Summary of Comments on P:\100\100.065\constr\storm
sewer\100.065-COVER-STM C0.1 (1)

CORE	
DATE	3/29/2022
BY	dsdrice
CHECKED BY	RSchindler
DATE	4/15/2022
PROJECT	AT LINDEN, TEXAS
SHEET NO.	42
TOTAL SHEETS	42

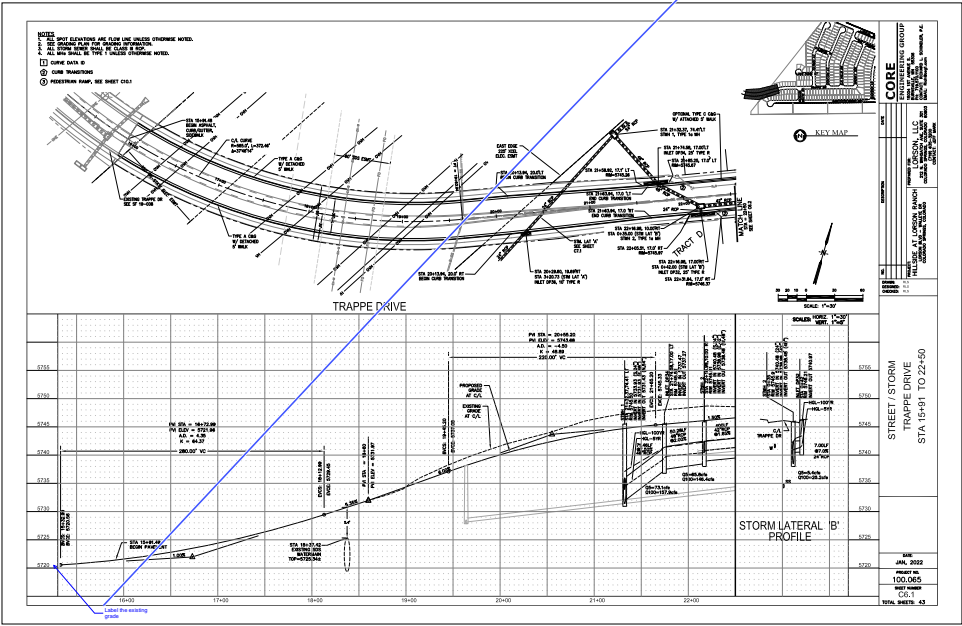
Label the existing grade

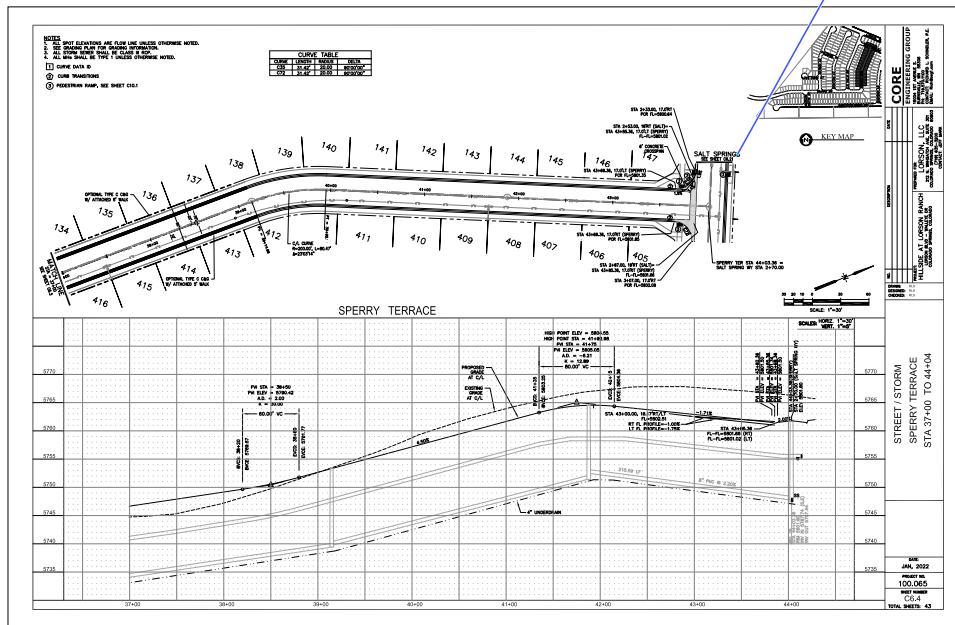
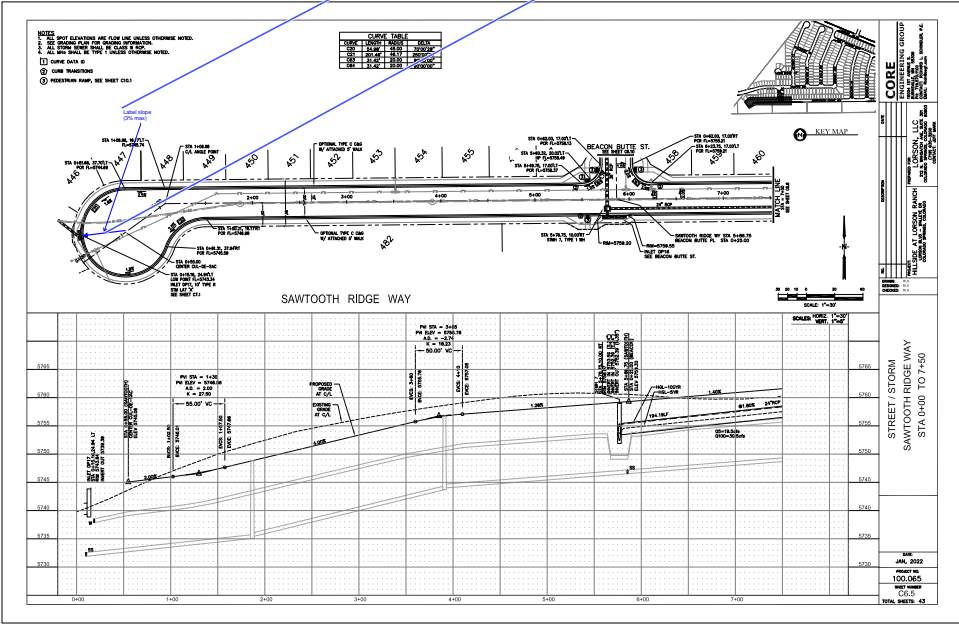
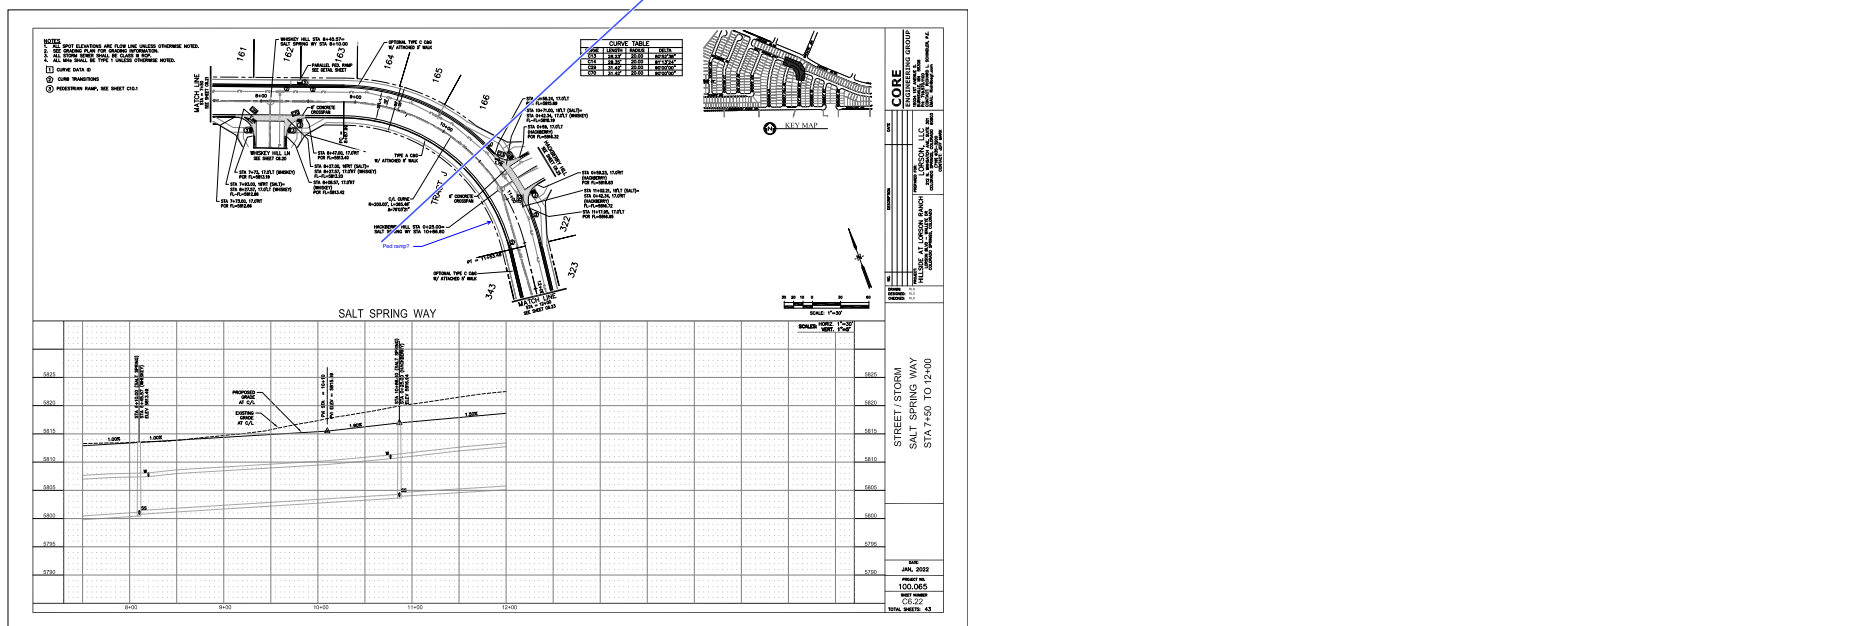
Label slope (3% max)

5 Author: RSchindler Subject: Sticky Note Date: 4/15/2022 8:28:05 AM
SLOPE ADJUSTED TO 3%

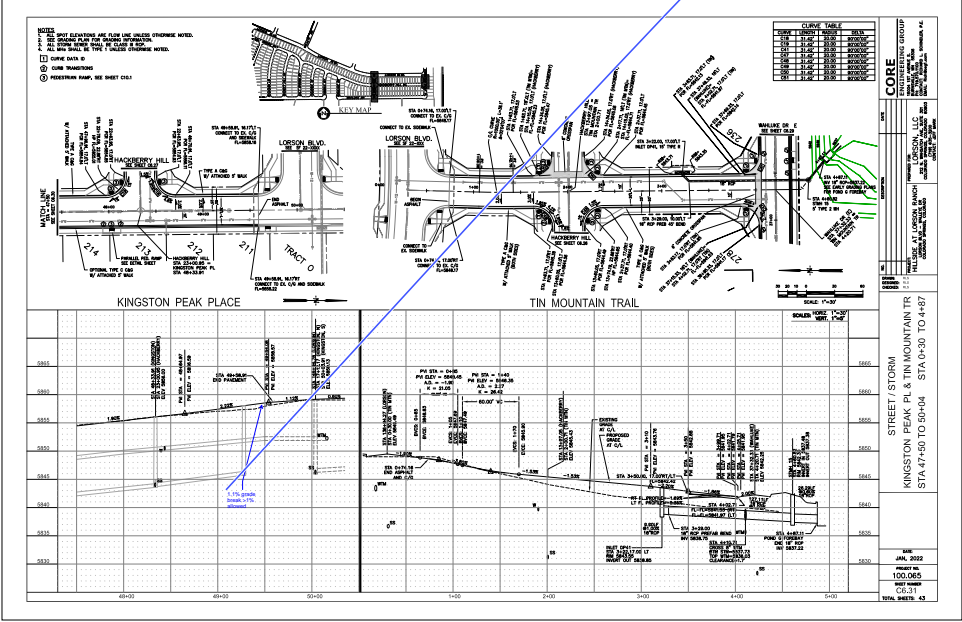
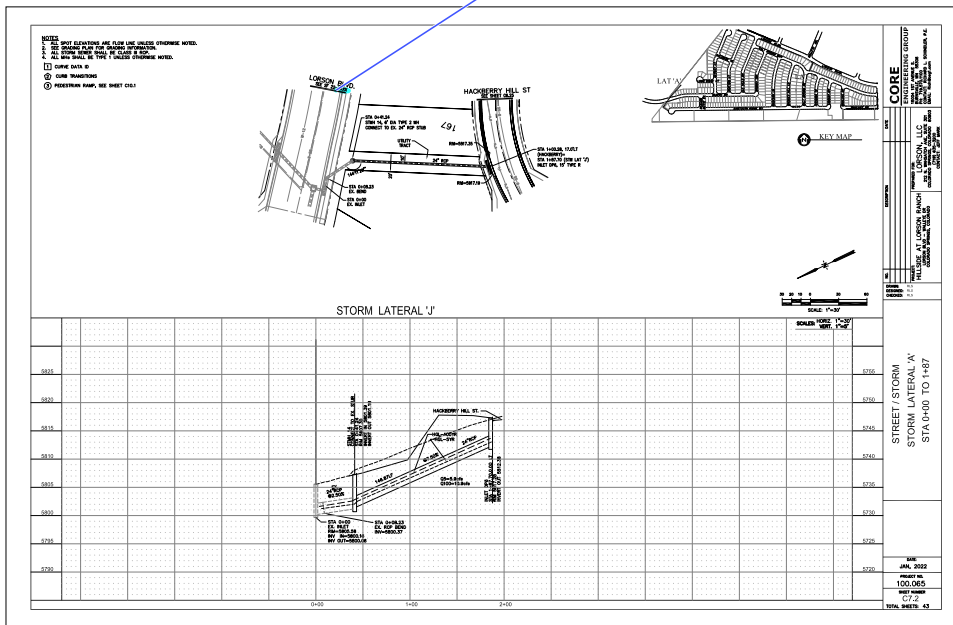
1.1% grade break >1% allowed

SLOPE CHANGED
